Product Change Notification

108474 - 01

Change Notification #: 108474 - 01
Change Title: Intel(R) IP Network Server NSC2U, PCN 108474-01, Product Discontinuance, Replaced by new product code, new features include: Chassis modifications allowing support for 2.5 inch SATA Hard Drives, support additional rack mount kits, add plastic cap to metal filler, Reason for Revision: Update product codes and MM numbers; incorporate PCN#108531, PCN#108461
Date of Publication: August 28, 2008

1. Revised the 40mm fan set mounting feature to remove fan vibration from the hot swap drive cage.

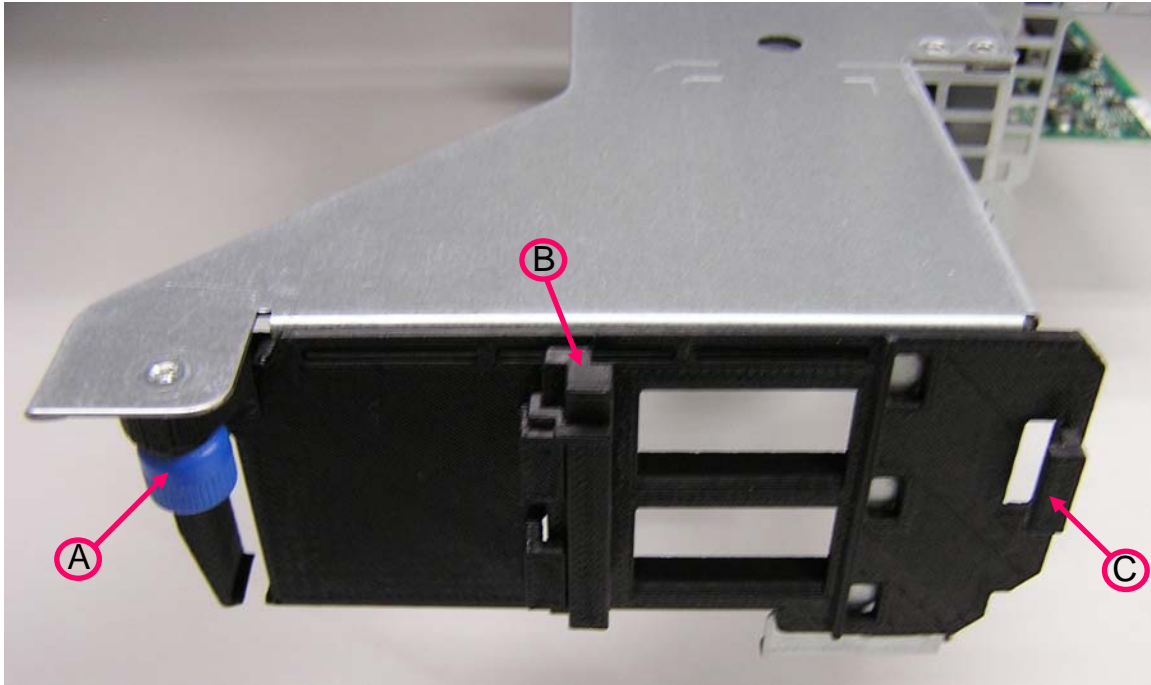
The revised 40mm fan set assembly mounts to the full length PCI board retention bracket and includes vibration dampening rubber grommets.

Revised PCI board retention bracket

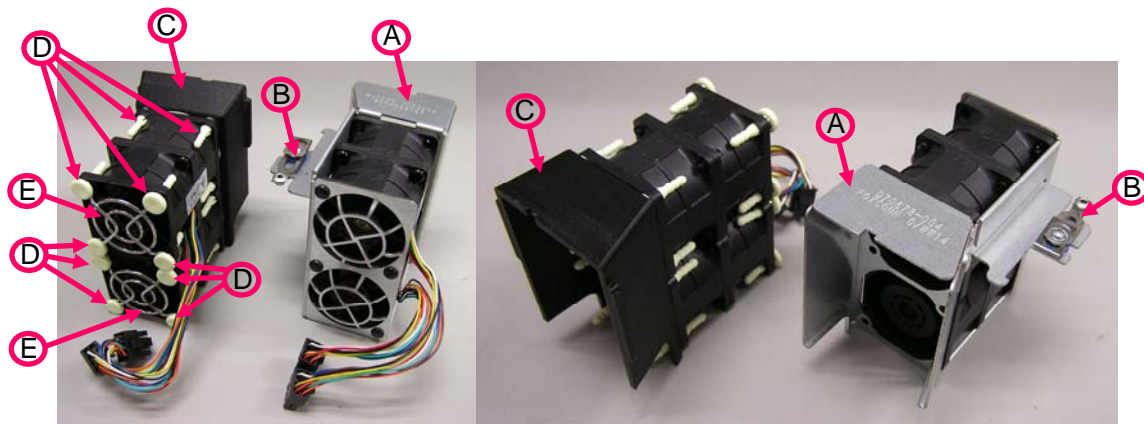
The revised full length PCI board retention bracket includes a "slide-on" feature to retain the 40mm fan baffle. Detail of the revised bracket is in the next section.

- (A) Mounting screw is the same as on old bracket
- (B) Slide pin retains one side of the 40mm fan baffle
- (C) Lip feature retains the right side of the 40mm fan baffle

Revised 40mm fan module

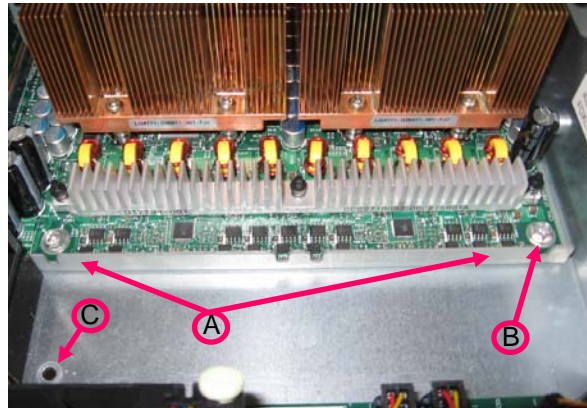
- (A) Removed metal housing
- (B) Removed mounting screw feature
- (C) Added plastic mounting/baffle
- (D) Added rubber grommets (color is grey)
- (E) Added wire finger guard

Revised 80mm fans mounting location
(Note: fan module is removed)

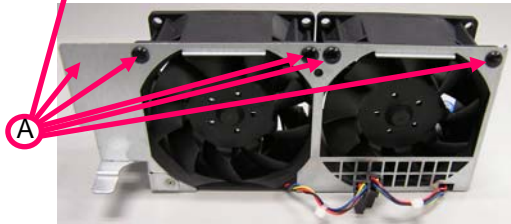
- (A) Added alignment bracket for fans
- (B) Added board/bracket retention screw
- (C) Removed the fan bracket alignment stud

Revised processor /memory duct

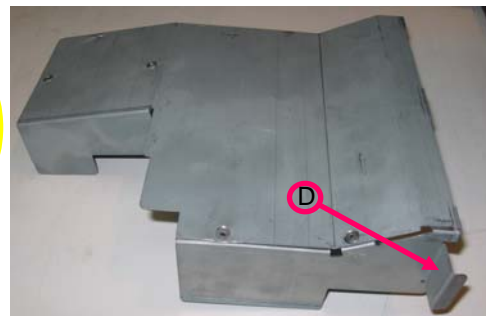
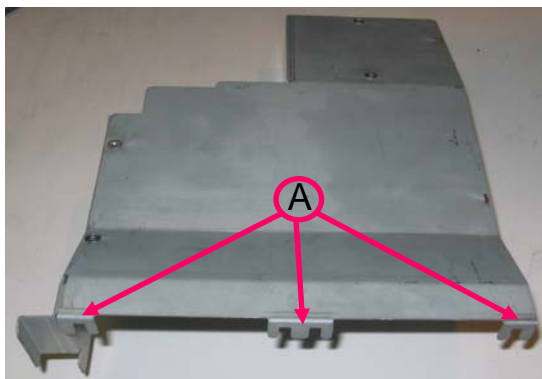
- (A) Removed metal shroud that covered 80mm fans & FPIO board
- (B) Moved baffle wall toward DIMMs creating more space for PCI board
- (C) Removed alignment slot and retention screw
- (D) Added air dam feature to maintain proper air flow

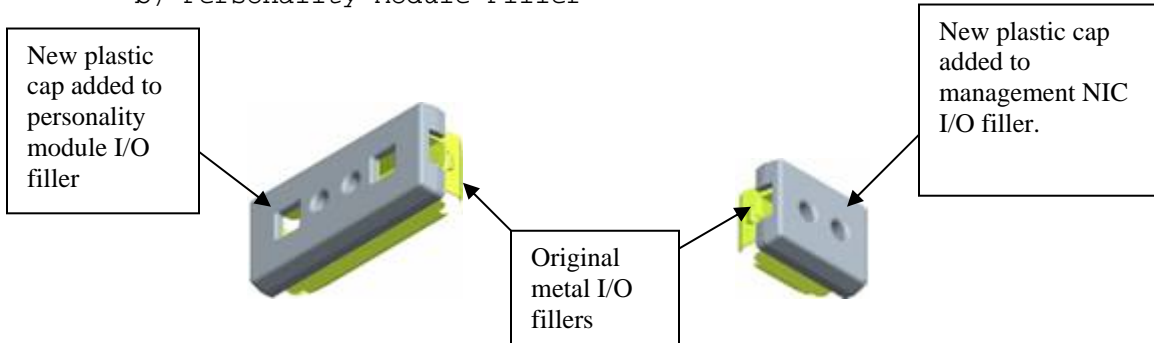
Intel added a total of eight PEM nuts to the sides of the base chassis to enable support for three additional rack mount kits, AXXBASICRAIL, AXXBASRAIL13, or AXXHERAIL. Ordering information for these kits and other accessory items is listed in the Configuration Guide.

Three PEM nuts (size 10-32, labeled "A") and one PEM nut (size 6-32, labeled "B") are added to each side of the base chassis. See locations labeled "A" and "B" in the following diagram.
